**Re: Christina Lake Thermal Project Phase H and Eastern Expansion
Project Update and Supplemental Information Request 2 Responses
AER Application No. 1758947
EPEA Application No. 019-48522**

The purpose of this document is to provide responses to the Round 2 SIR package and provide updated information regarding the Project (Project Update). This document is organized into two parts as follows:

I:\CLIENTS\CENOVUS\14-1346-0011\mapping\MXD\C&R\SIR_Round2\ESRD_SIR_17_Figure_37_6.mxd

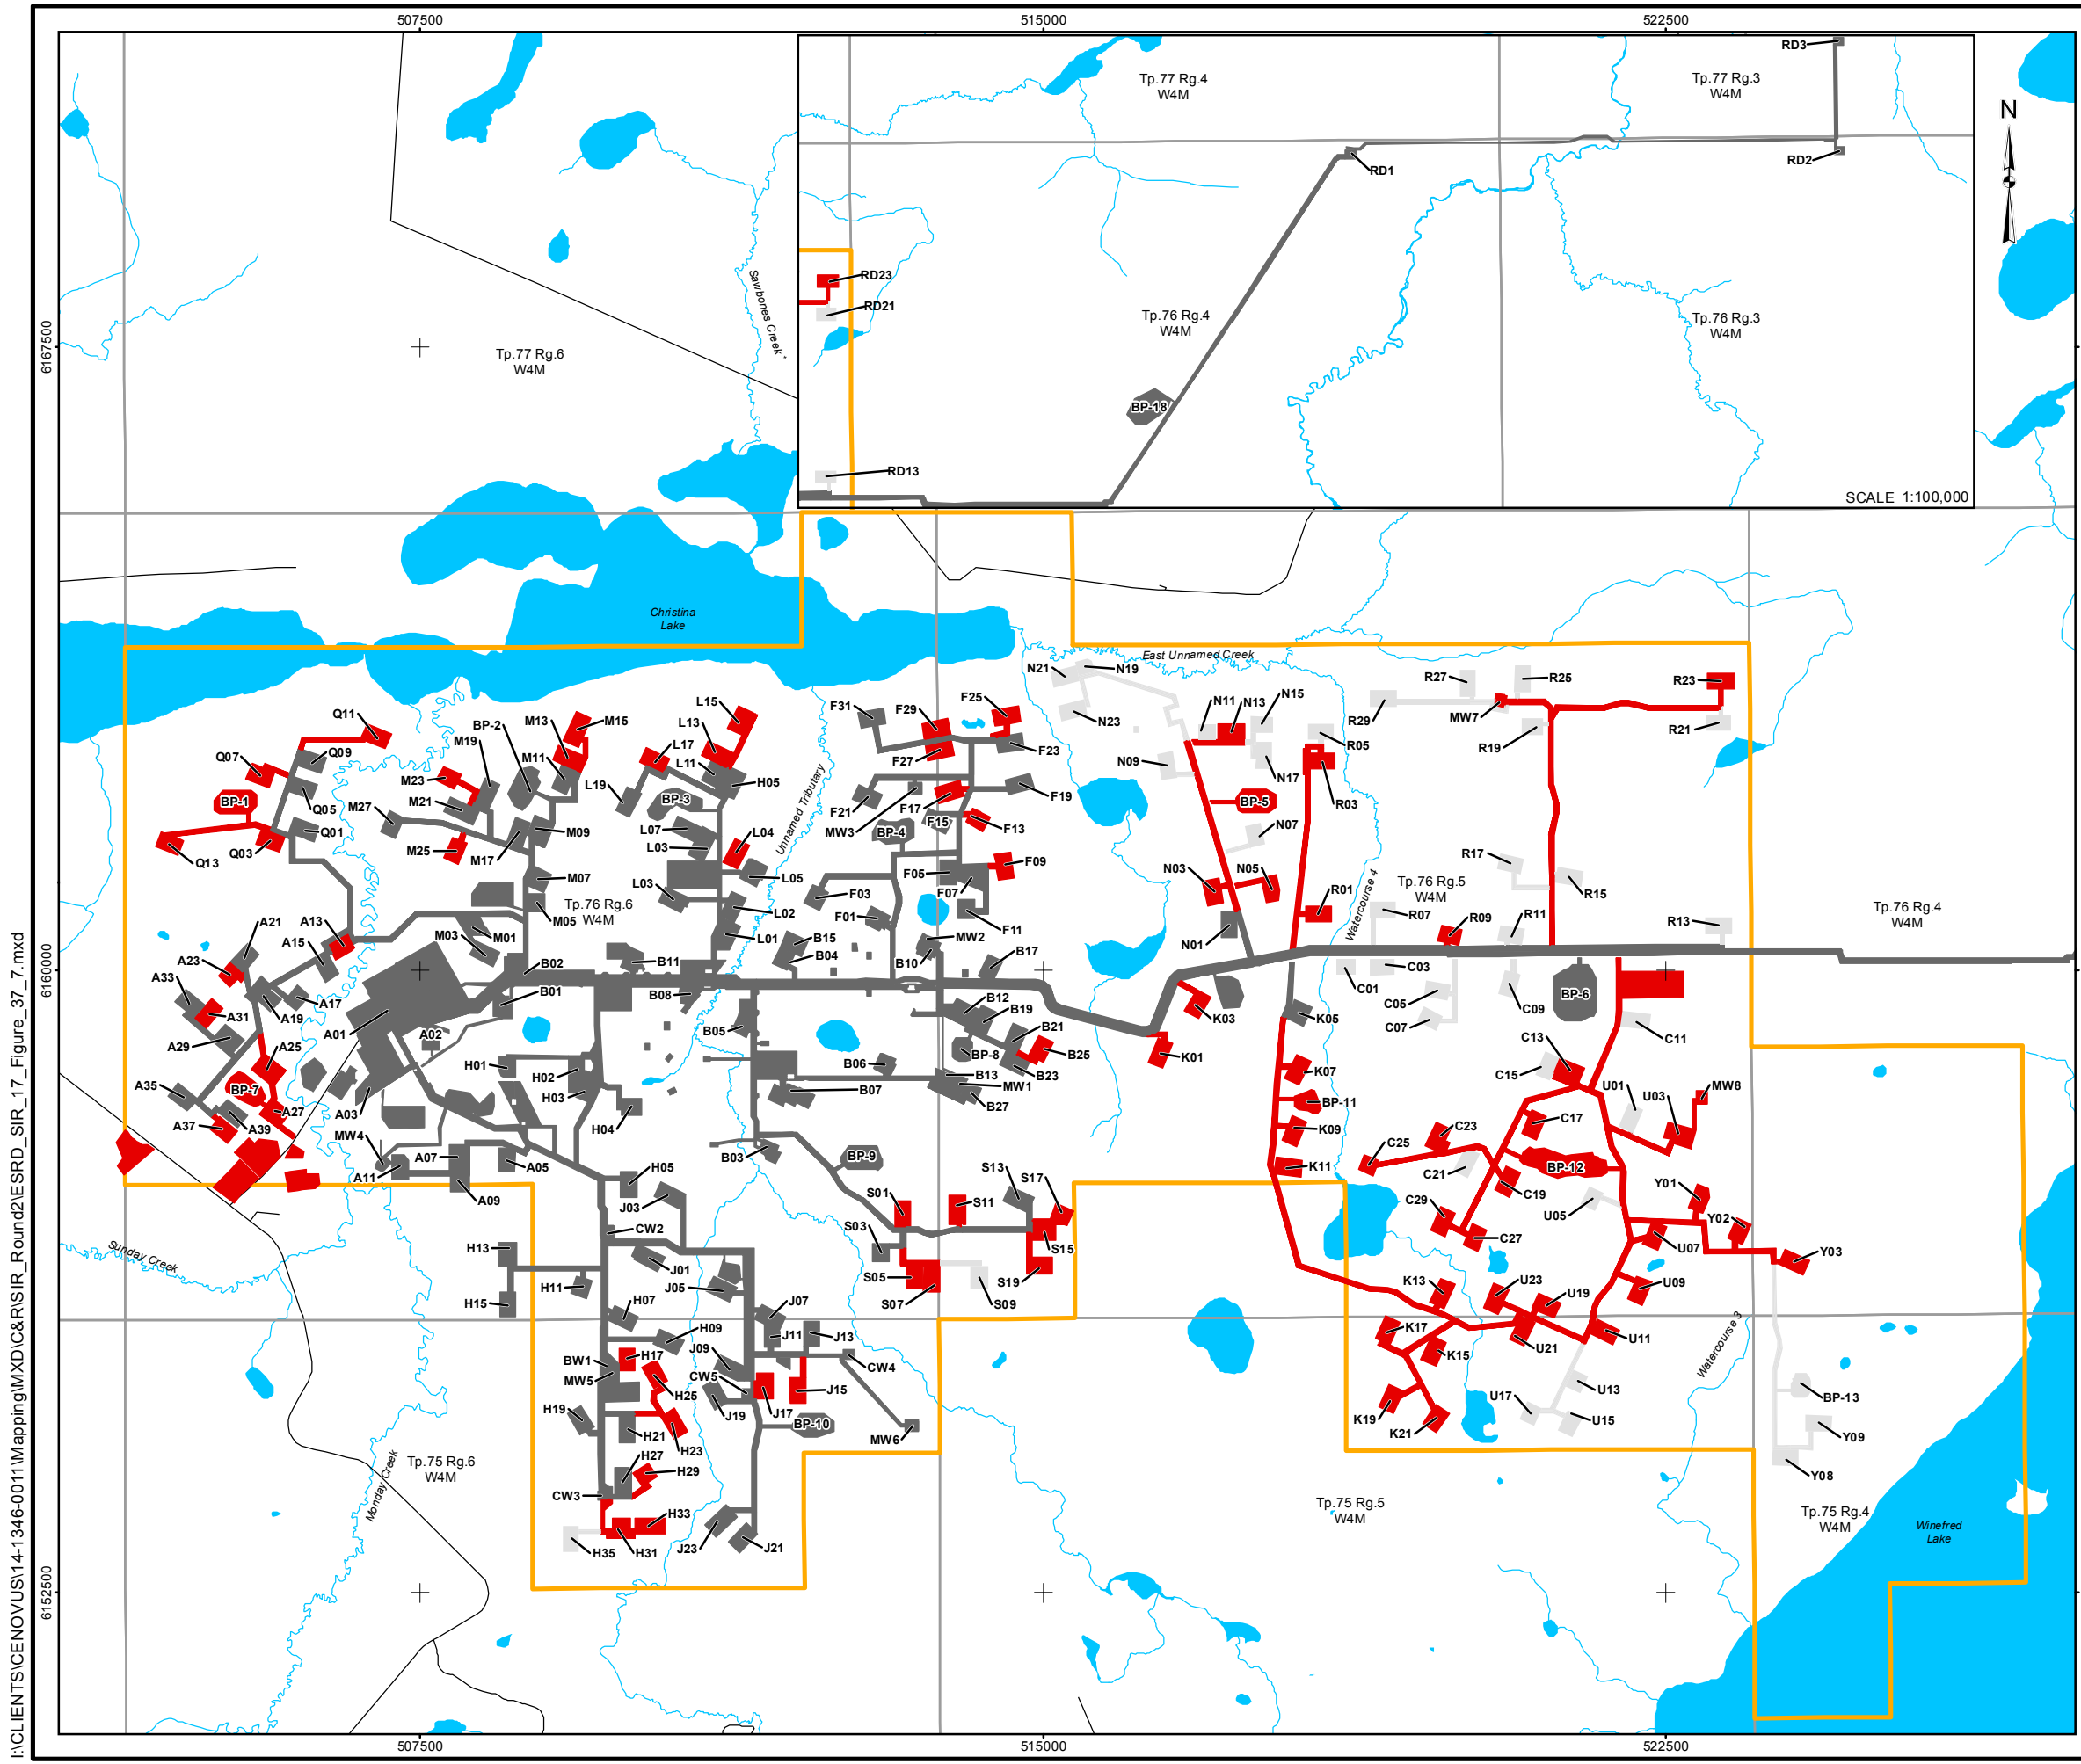
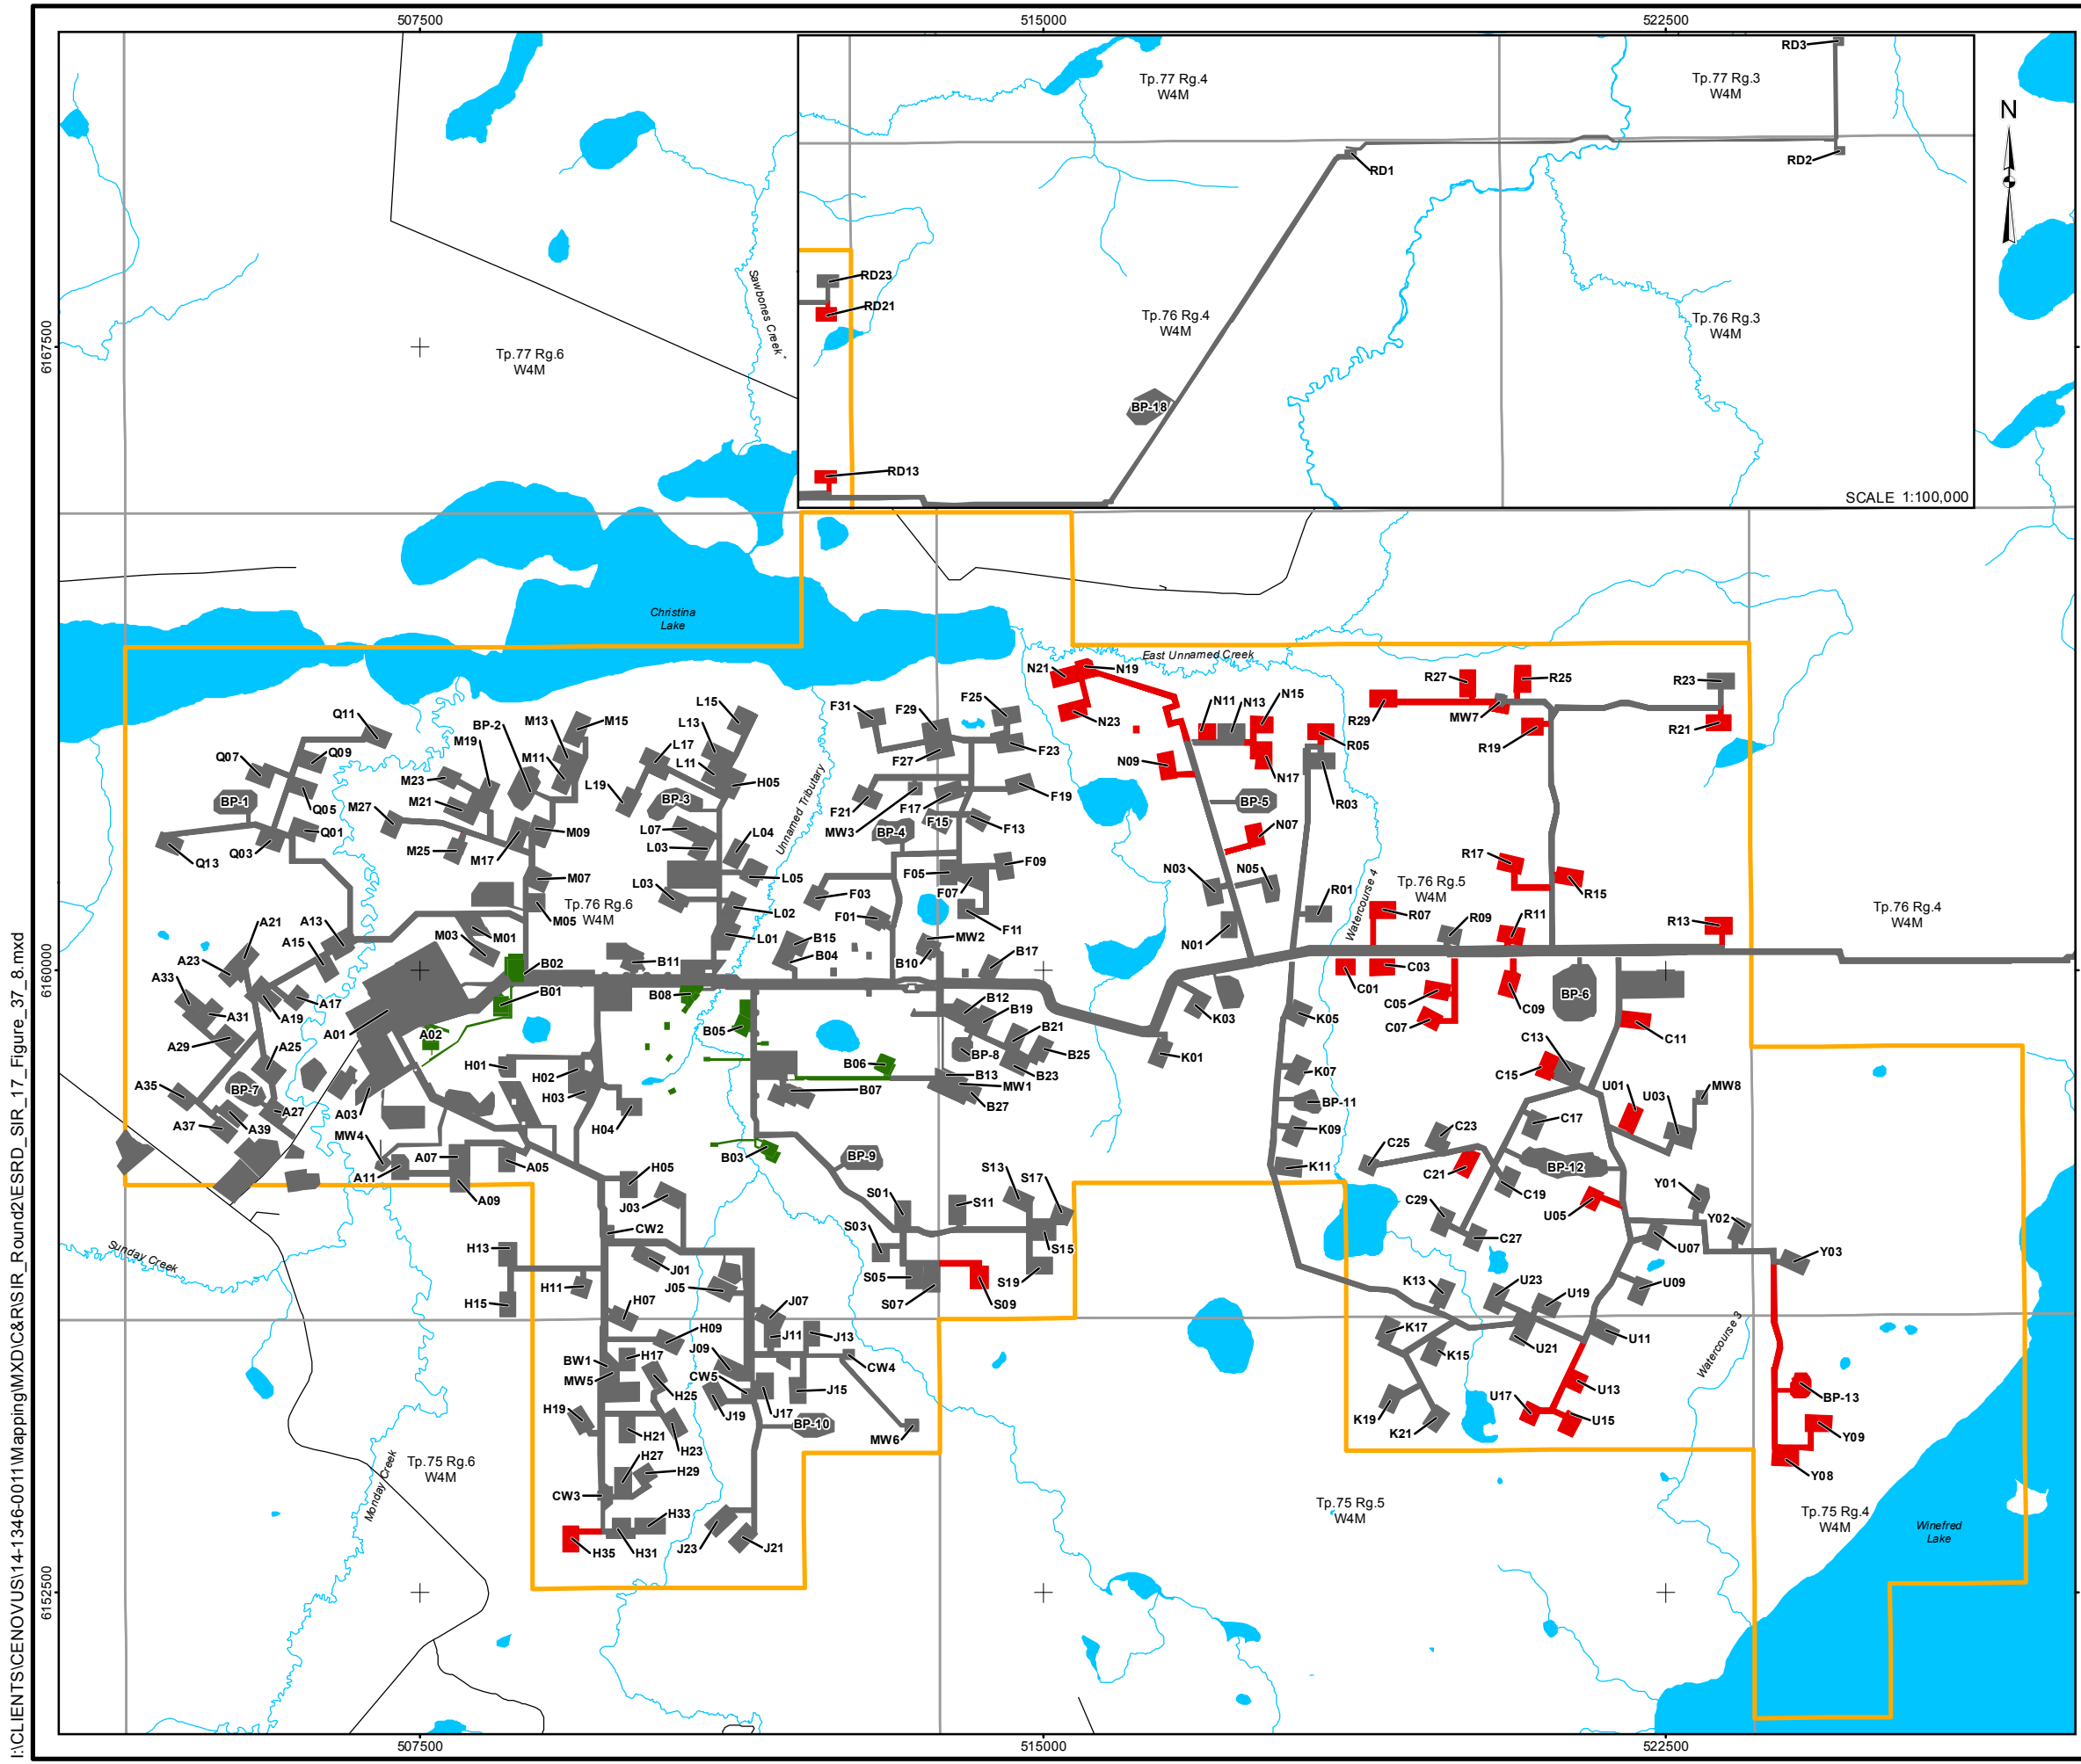
In Table 65-2, the column Unnamed (Monday) Creek appears to be mislabelled. All Figures in the SIR response 69 are mislabelled. In Figure 186-1, the sub-watershed is mislabelled.

Figures 69-1 to 69-13 from ESRD Round 1 SIR 69 have been revised and are presented as [Figures 37-1 to 37-13](#).
